# CITY OF ALBUQUERQUE

RE: **Andalucia Phase 1, Bldgs A, B, and C**  
**5600 Coors Blvd NW**  
**Request for Certificate of Occupancy – Permanent**  
**Hydrology Final Inspection - Approved**  
**Engineer's Stamp Date 2/3/17 (E12D015D)**  
**Certification Dated: 4/25/18**

Re: Andalucia Phase 1 Bldgs A, B and C (Hydro # E12D015D) comment letter

**GRADING AND DRAINAGE PLAN**

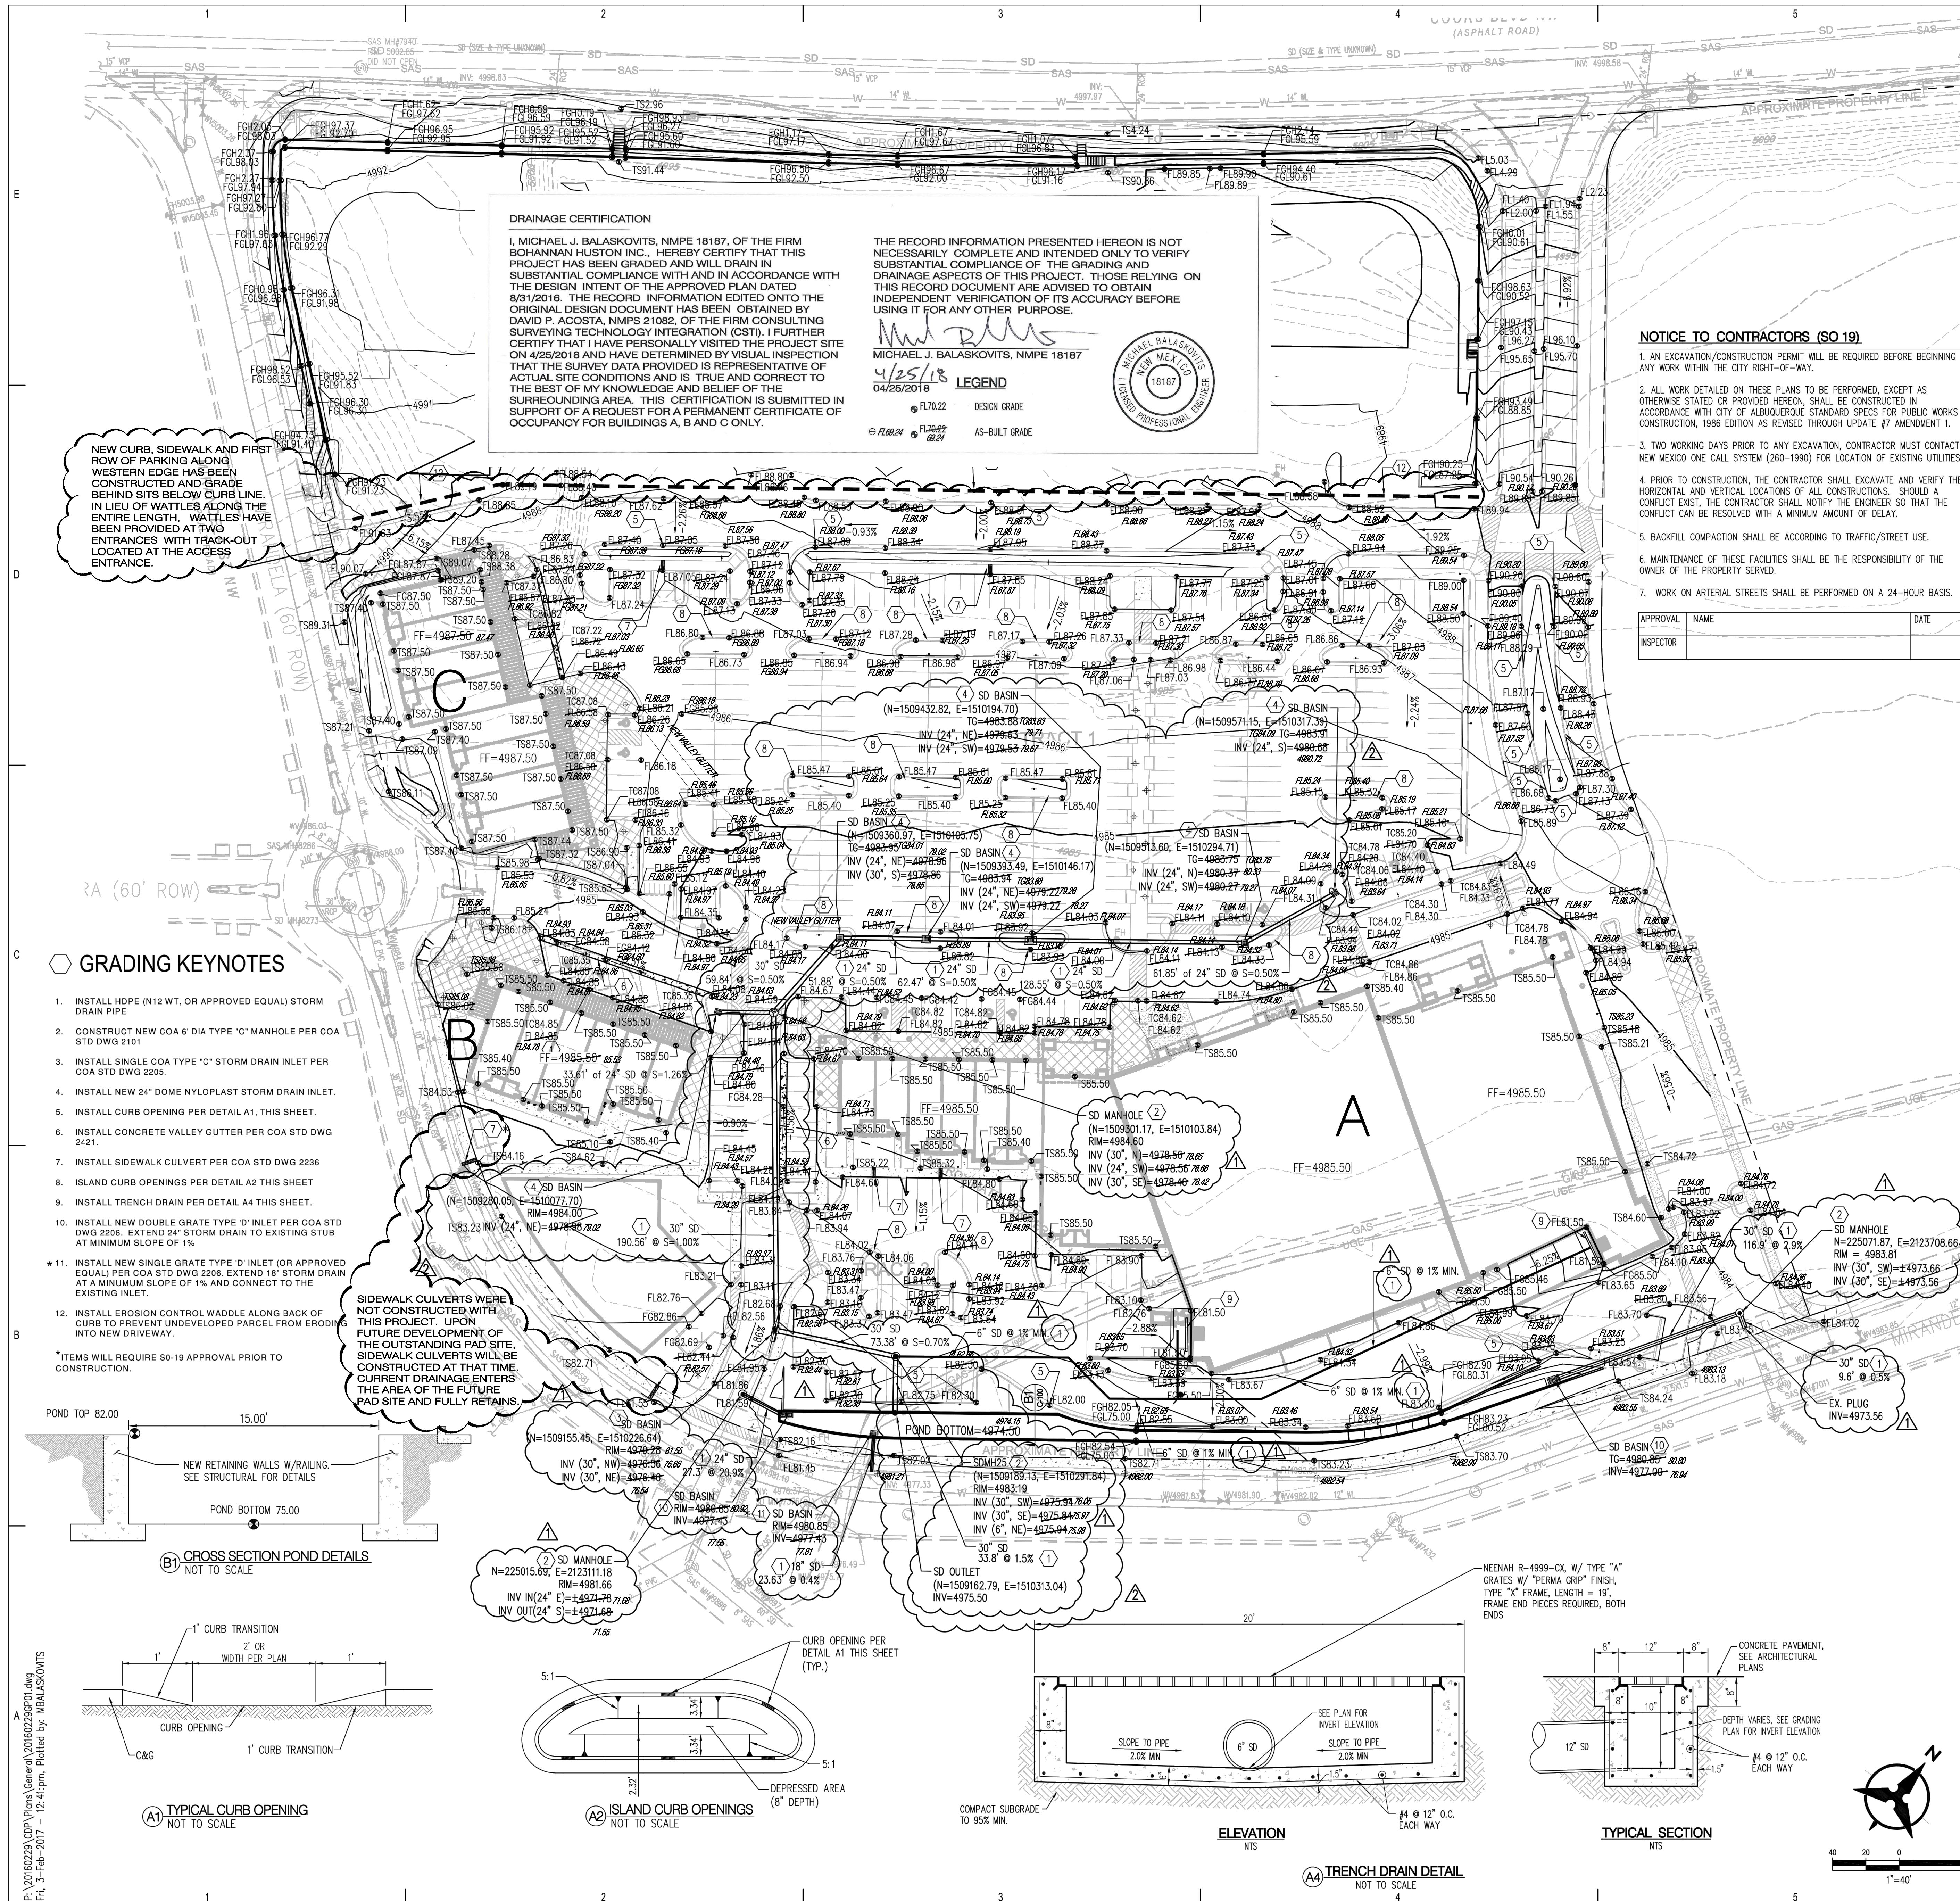
1. Include detailed descriptions of what Revisions 1 and Revisions 2 are. This may be included on the Grading Plan or as a separate letter.

2. The Drainage Plan and its calculation will need to be updated to reflect these revisions and included with the submittal with the new stamp date.  
*Response: The drainage and hydrology calculations noted within the original approved drainage management plan have not deviated from the original intent. The revisions were intended to provide clarity in the field resulting in a better product which more effectively meets the intent of the approved plan. Given the above list of revisions we do not plan to issue a revised drainage management plan.*

3. The sidewalk culverts behind building B along Mirandela, were not constructed and should be as-built as such. Include justification for not constructing these culverts as a separate paragraph in the drainage certification.  
*Response: The sidewalk culverts were noted on the recent drainage certification submitted 4/20 as to be constructed in the future upon development of the outstanding building pad. These culverts can be deferred to the future as the current drainage enters depressed ponding areas that will not adversely affect the buildings during large storm events.*

4. The stairwells through the retaining walls along Coors and the north driveway are incomplete or were not constructed and should be as-built as such. Include justification for no constructed these stairwells as a separate paragraph in the drainage certification.  
*Response: The stairwells along Coors currently access the Phase 2 project and cannot be used until Phase 2 is complete. The developer has opted to not construct them at this time to help prevent access to the construction area. The stairs will be addressed prior to acceptance of the Phase 2 work.*

5. The loading dock behind PetSmart is incomplete and should be as-built as such. Permanent CO cannot be approved with the loading dock being complete. However, a Temporary CO can be granted to allow for this section to be completed later. Also include justification for not constructing this loading dock in the drainage certification.

6. The erosion control wattles along the upstream building pads near Coors (key note 12) were not installed. These need to be installed prior to CO. Alternatively, curb cutbacks and track-out can be used and wattles added only at the closed drive entrances: this will need to be as-built as such, with justification added to the drainage certification.

*Response: The revisions completed were specific to cosmetic changes that are generally addressed in a sketch or other type of drawing issued in the field. New sheets were submitted for ease of tracking. The calculations and hydrology did not deviate from what was originally approved.*

- a. Additional detail for the manhole between buildings A and B was provided (Rim and Inverts)
- b. Rim elevation of curb inlet was corrected to reflect the proper design surface at the east end of site.
- c. Further clarification of the inlets within the pond was provided to help construct them in the field.
- d. Additional detail for the manhole at the northeastern entrance was provided (Rim and Invert).
- e. Additional detail for the manhole connection of the inlet from the pond near the roadway was provided (Rim and Inverts)
- f. Invert to 30" storm drain outlet was provided
- g. SO-19 designation (\*) was added to additional inlet in pond connecting to existing inlet within public roadway.
- h. Storm drain pipe slopes and sizes were included were not previously provided.
- i. Connection to existing storm drain at the northeast corner was further defined.

- j. *The curb and gutter was adjusted as a part of an administrative amendment west of Building A, resulting in better circulation through the site. The inlets located in the landscape strip were adjusted minorly to reflect the new median curb. A manhole and a section of storm drain was removed which increased efficiencies by incrementally increasing SD slopes. An additional inlet was added to one of the new islands to ensure it drained accordingly. The basin boundaries, and reductions in the storm drain capacity did not occur and the site drains as originally noted in the approved Drainage Management Plan.*

*Response: The loading dock has been constructed and this comment has been addressed.*

*Response: It is noted on the drainage certification dated 4/20 that the wattles have been installed at two entrances and track-out has been provided in one of the other entrances for access. New curb and sidewalk along the majority of the west edge, along with the first road of parking stalls has been constructed. The existing grades internal to Phase 2 sit below the top of curb or sidewalk along this edge allowing water to pond behind them until it fills up and flows over the top of sidewalk. During large storm events, this prevents sediment from entering the existing asphalt drive.*
